APPLICATION FOR PERMIT TO DRILL OR REENTER

2. Name of Operator PHILLIPS PETROLEUM COMPANY		7. If Unit or CA Agreement, Name and No.
3a. Address 5525 HWY. 64 FARMINGTON, NM 87401		8. Lease Name and Well No. SAN JUAN 30-5 UNIT 214A
3b. Phone No. (include area code) Ph: 505.599.3454 Fx: 505-599-3442		9. API Well No. 30-039-27251

The geological tops were wrong on the original Drilling Prognosis submitted with the APD. See attached for new drilling prognosis.

DRILLING PROGNOSIS

San Juan 30-5 Unit #214A

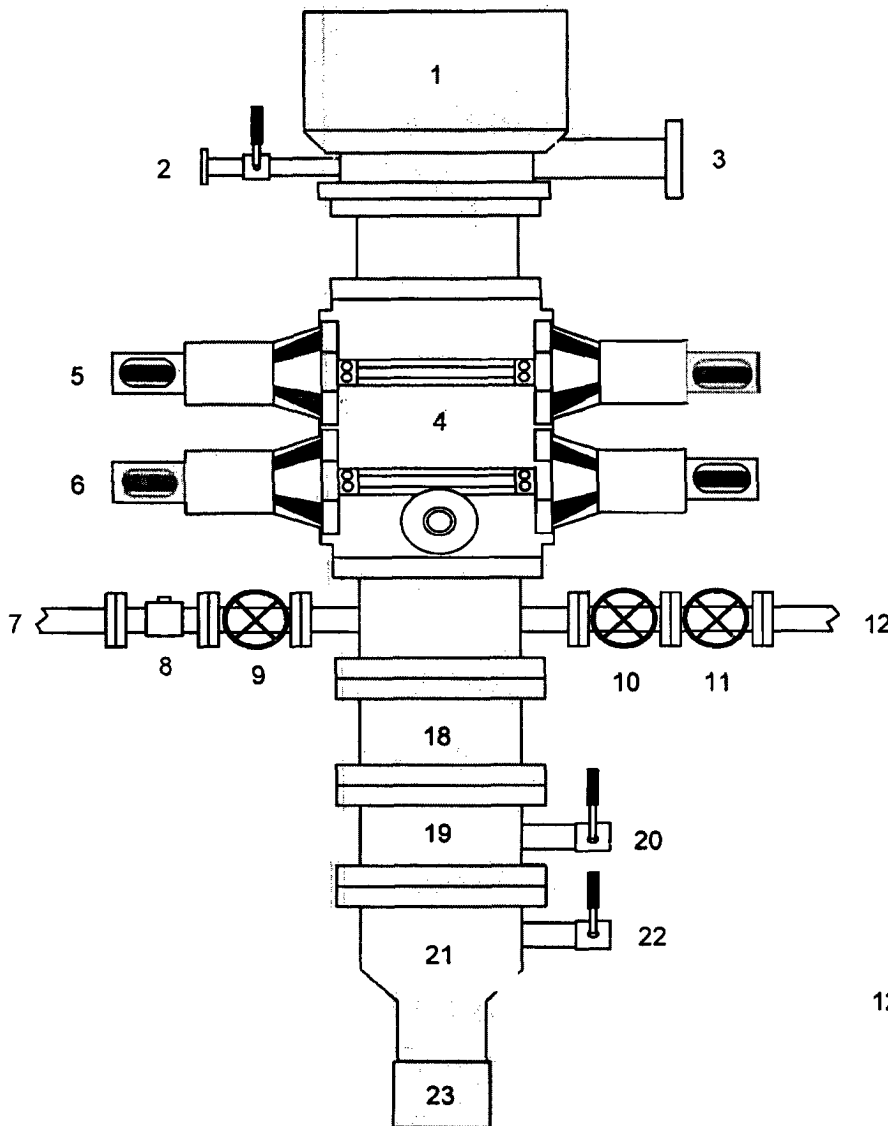
#9. Cement Program: Liner-if the coal is NOT clefted, a 4-1/2" 11.6#, J/K-55 liner will be run & set @ TD and tie 200' into the 7" shoe. It then would be cement in place. The well will be completed by fracture stimulation.

Will cement the Lead Slurry with Type III cement - 150% excess casing hole annular volume with Type III cement + 0.25#/sx Cello-flake + 5#/sx Gilsonite + 6% bwoc Bentonite + 10#/sx CSE + 3% bwow KCl + 4% bwoc FL-25 mixed + 0.2#/sx static free mixed at 10. ppg (2.52 cf/sx yield).

Tail - 50 sx Type III cement + 0.2#/sx Cello-flake + 1% CaClum Chloride mixed at 14.5 ppg (1.40 cf/sx yield = 70 cf).
